TRAILS AT ASPEN RIDGE FILING NO.2

EL PASO COUNTY, CO

ROADWAY & STORM IMPROVEMENT PLANS

FEBRUARY, 2020

DETAIL B
BIG JOHNSON DRIVE/ TURTLE LAKE WAY
INTERSECTION DETAILS

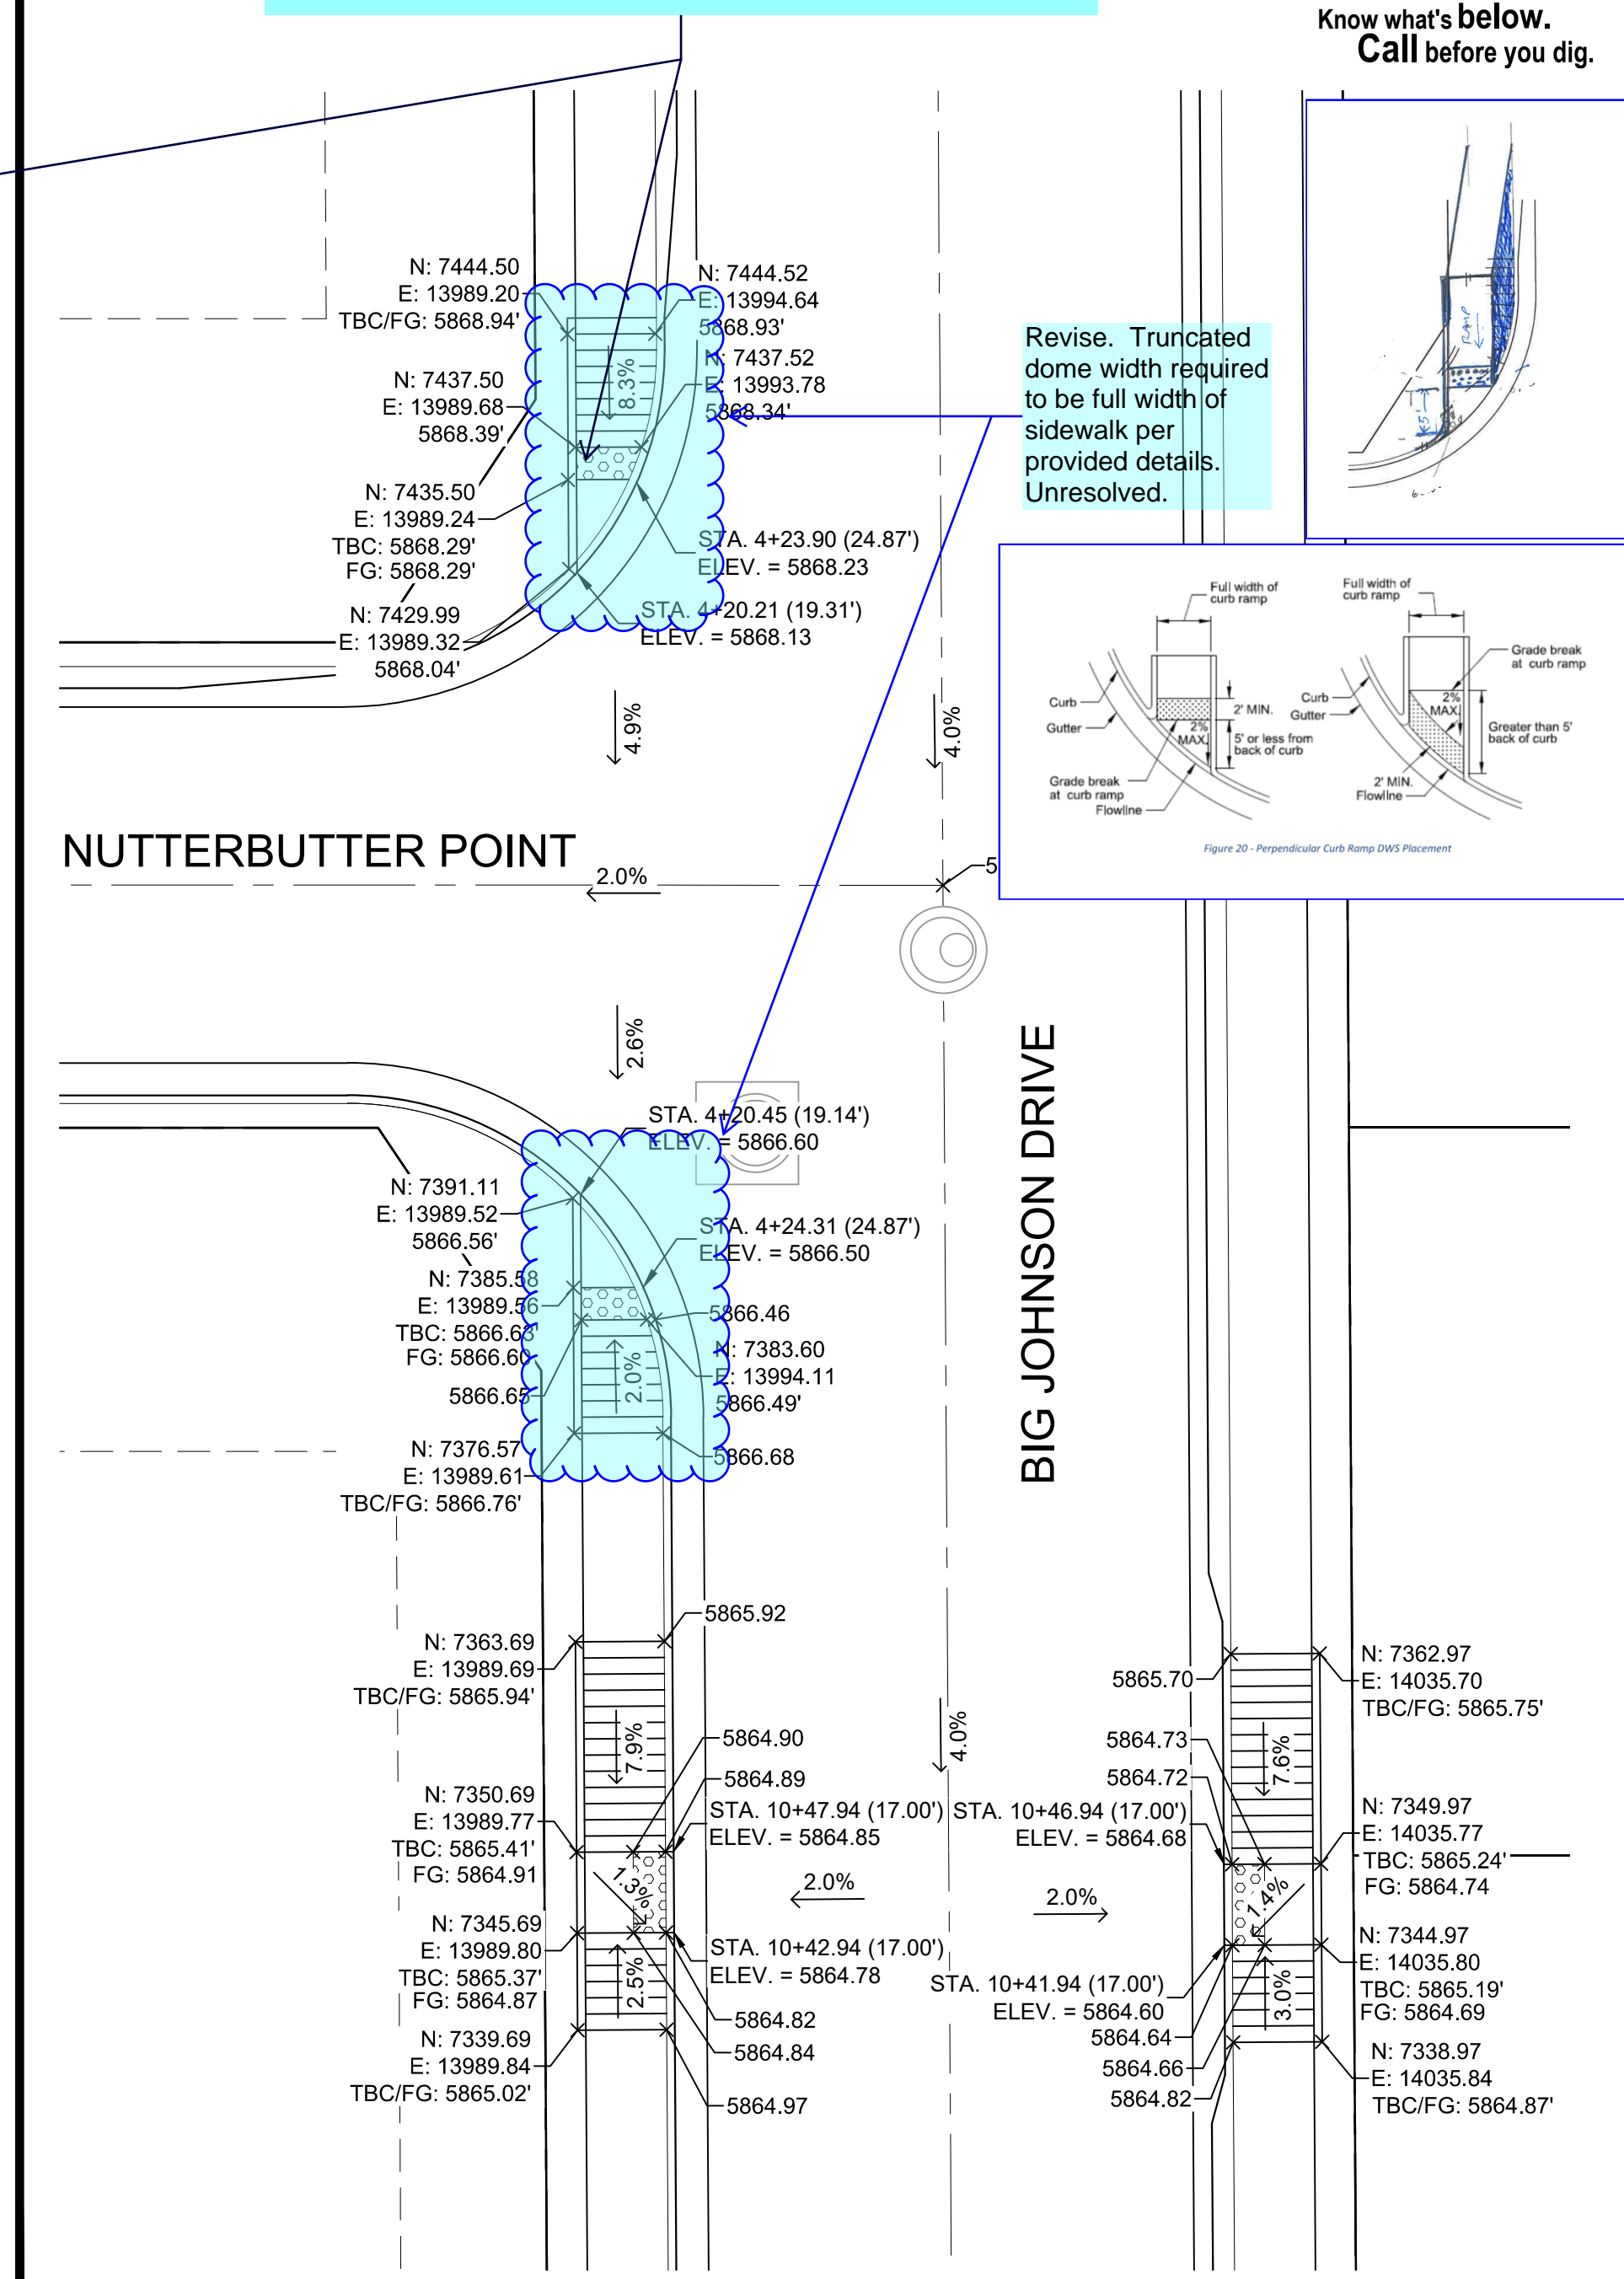
Per County detail SD_2-41 width at the truncated dome area shall be the same width as the sidewalk (5-ft)

Revise. Truncated dome width required to be full width of sidewalk per provided details. Unresolved.

TRAILS AT ASPEN RIDGE			
FILING NO. 2			
ROADWAY & STORM IMPROVEMENT PLANS			
INTERSECTION DETAILS			
DESIGNED BY: NMS	SCALE: 1" = 10'	DATE ISSUED: FEBRUARY, 2020	DRAWING No. RD21
CHECKED BY: NMS	HORIZ: 1" = 10'	SHEET: 24 OF 36	
	VERT: N/A

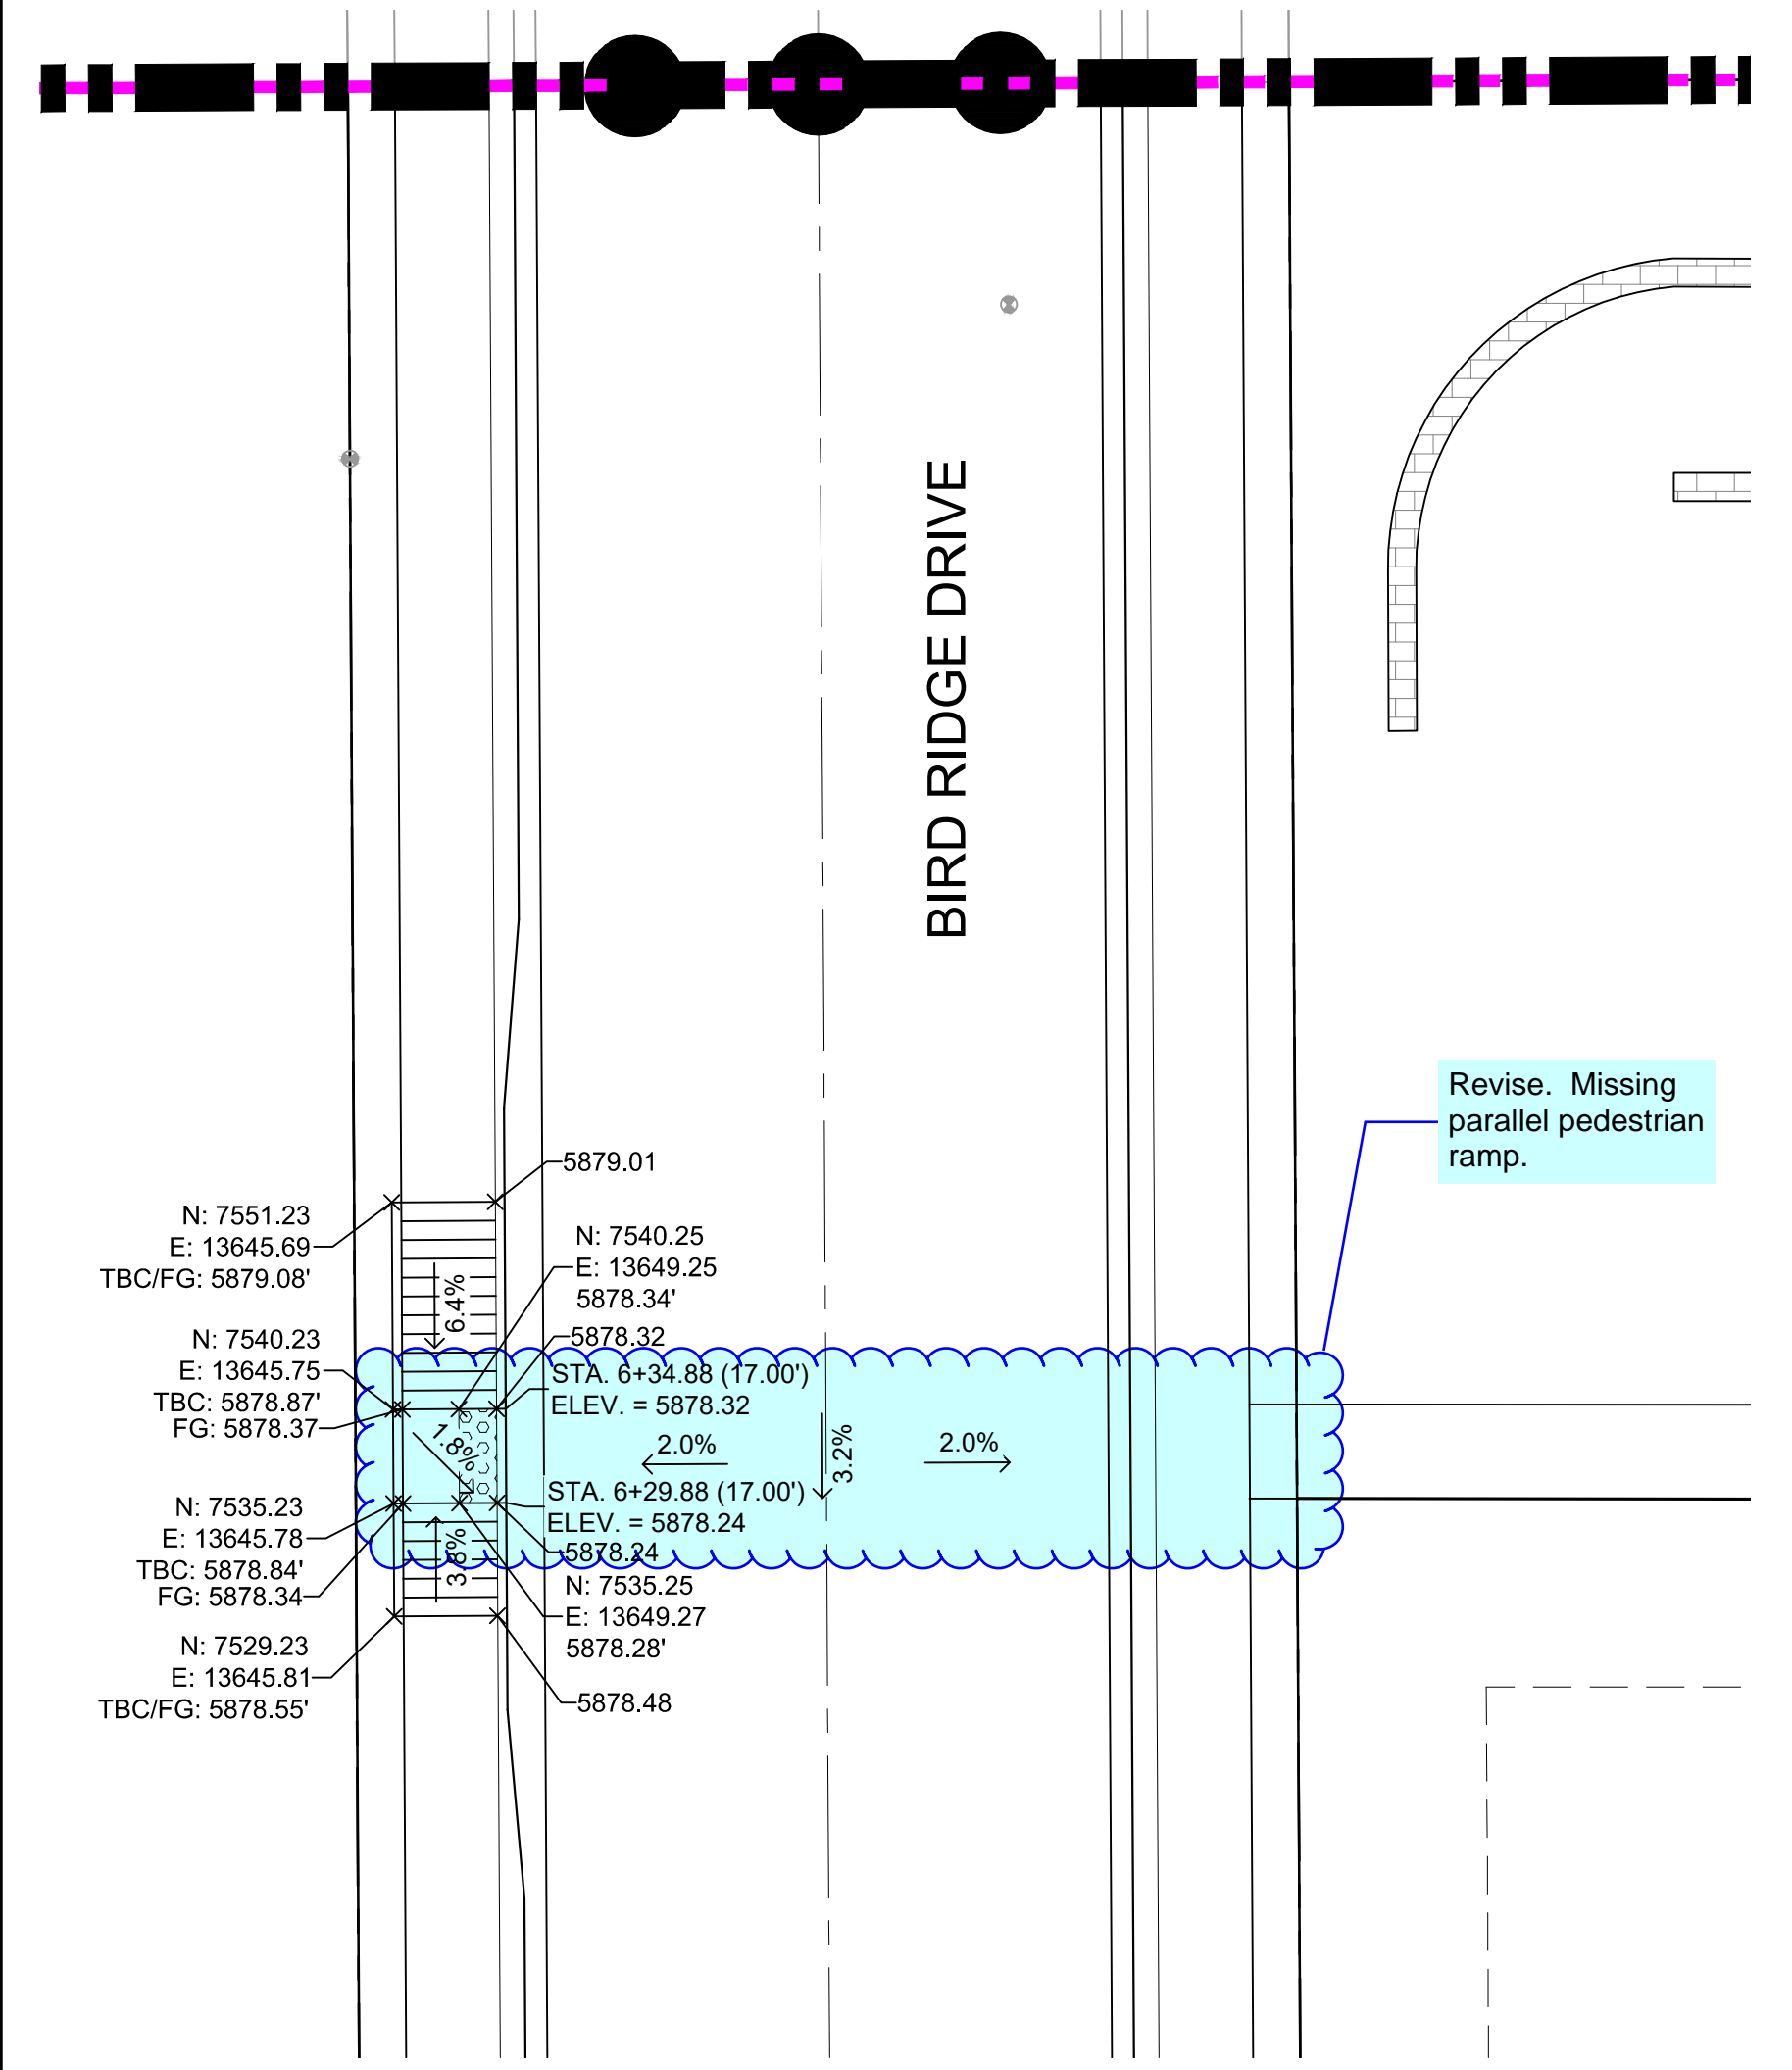
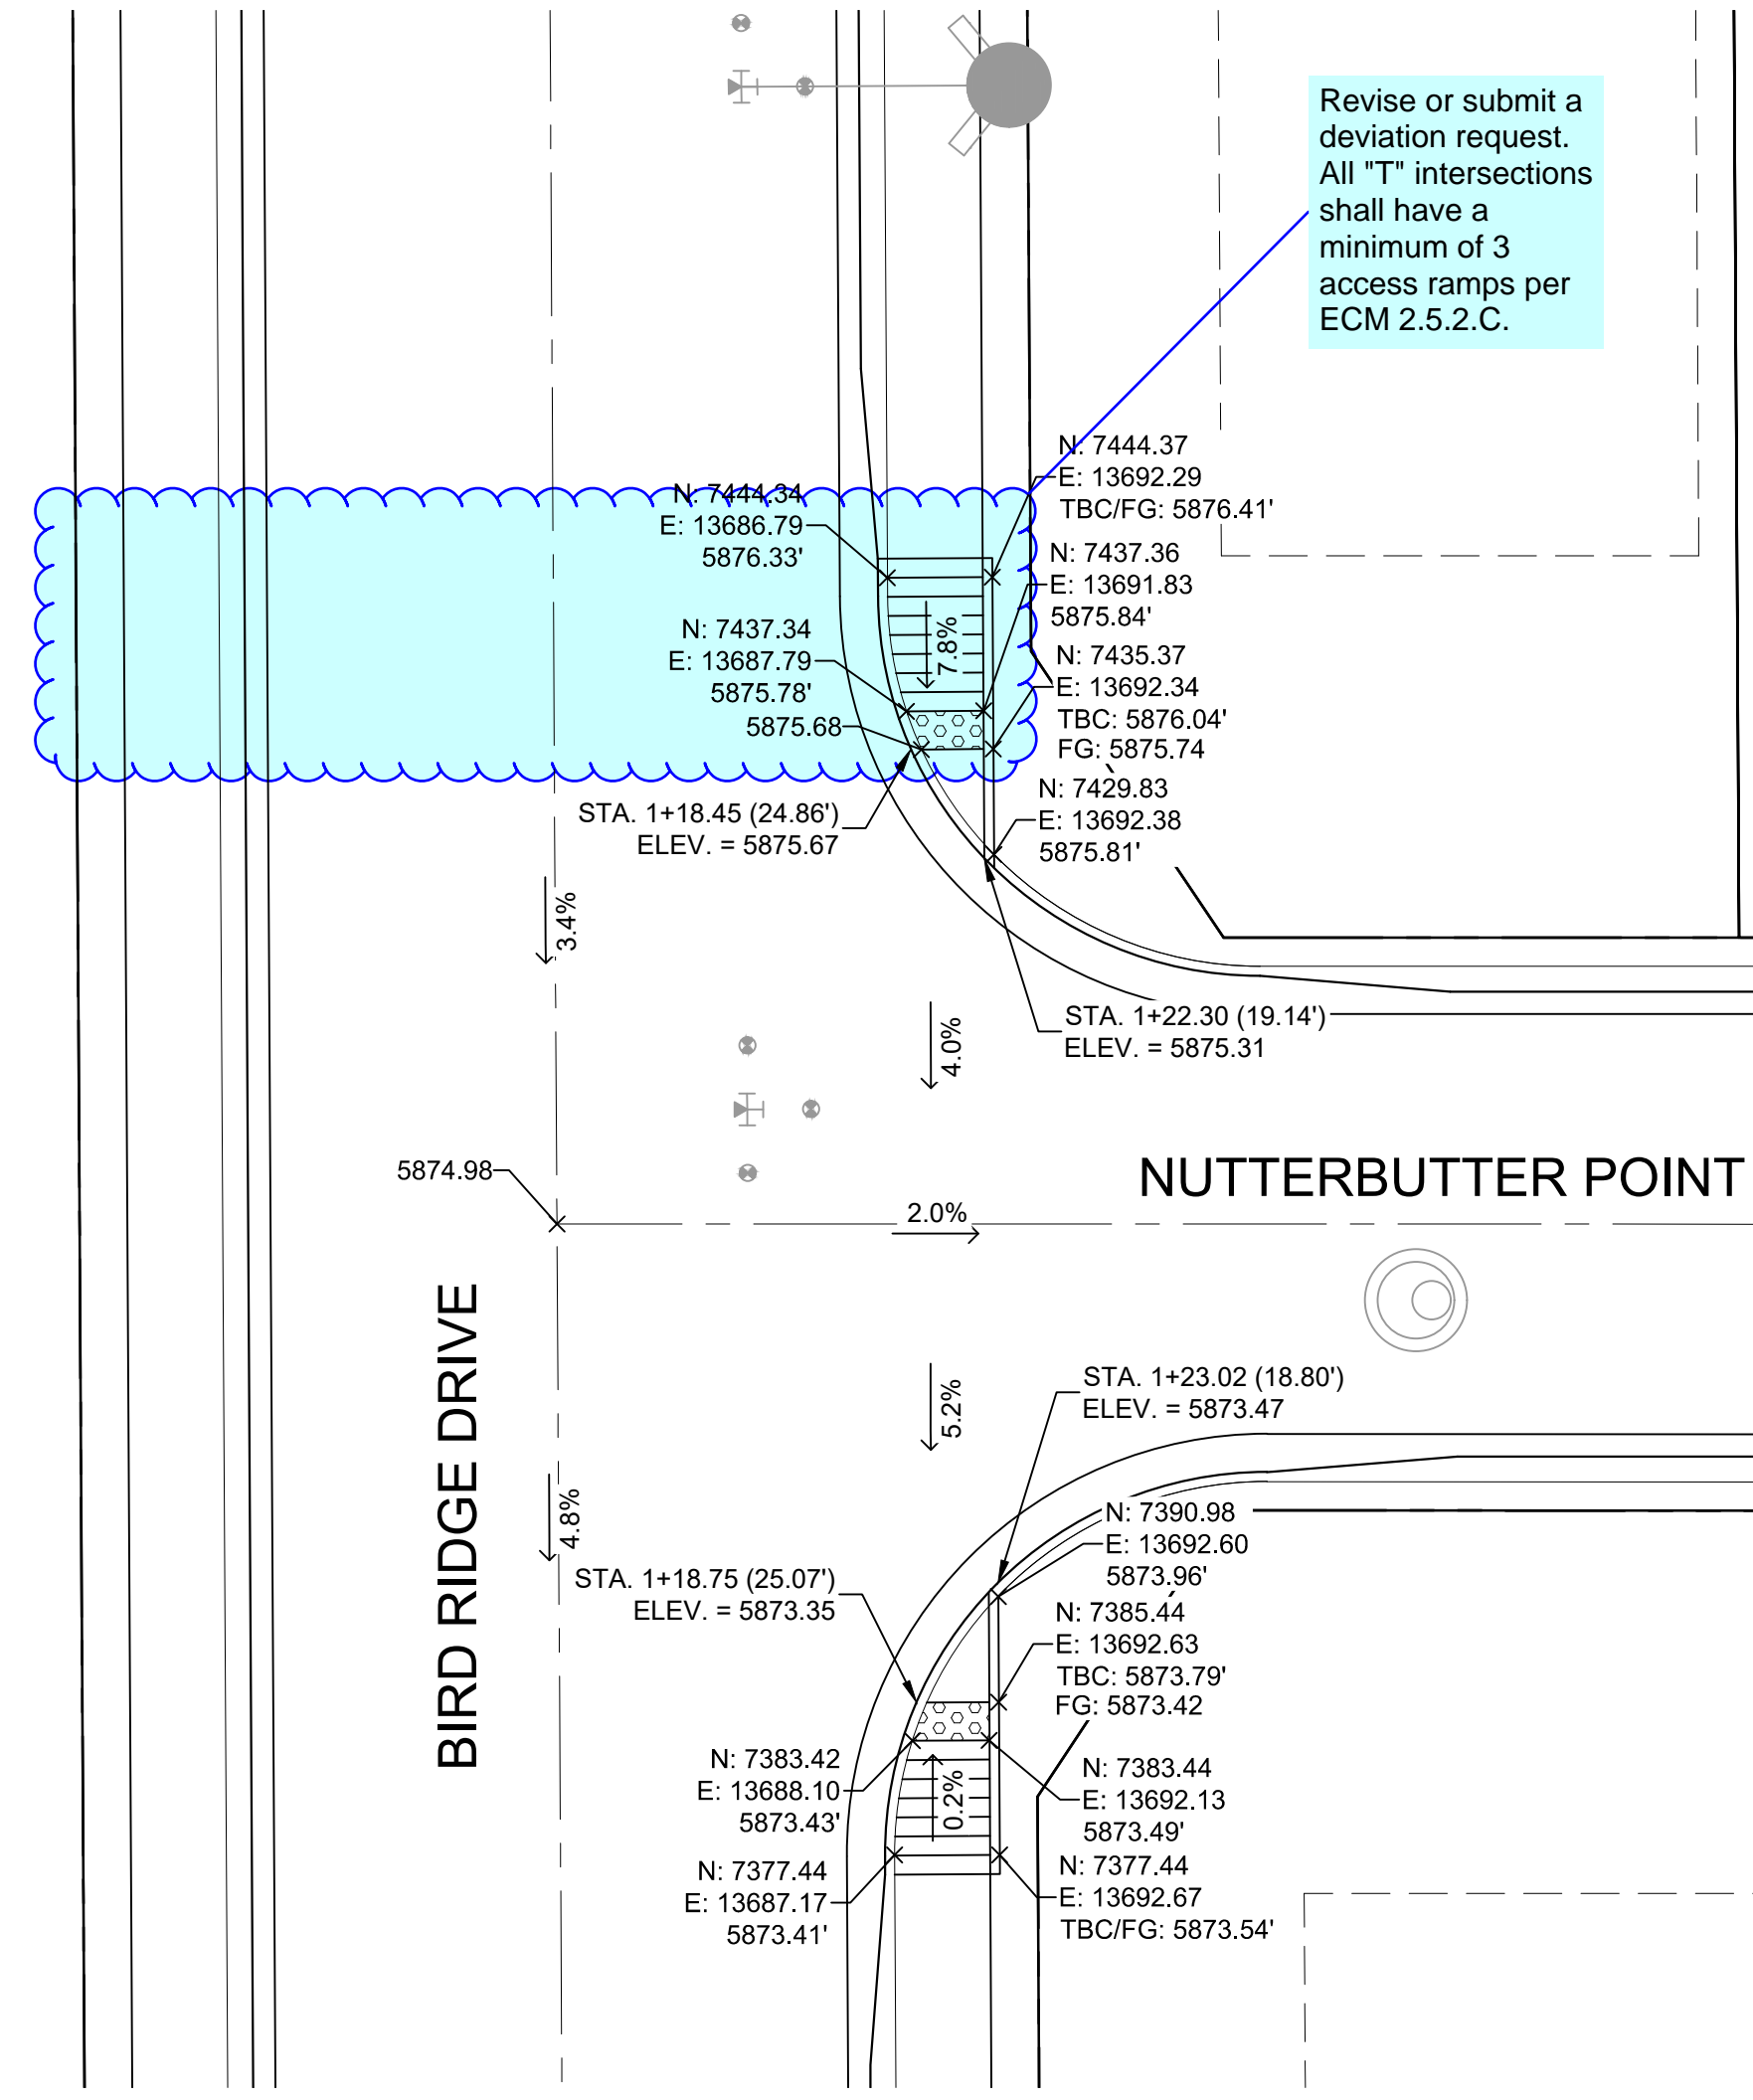
Revise or submit a deviation request. All "T" intersections shall have a minimum of 3 access ramps per ECM 2.5.2.C.

Revise. Missing parallel pedestrian ramp.
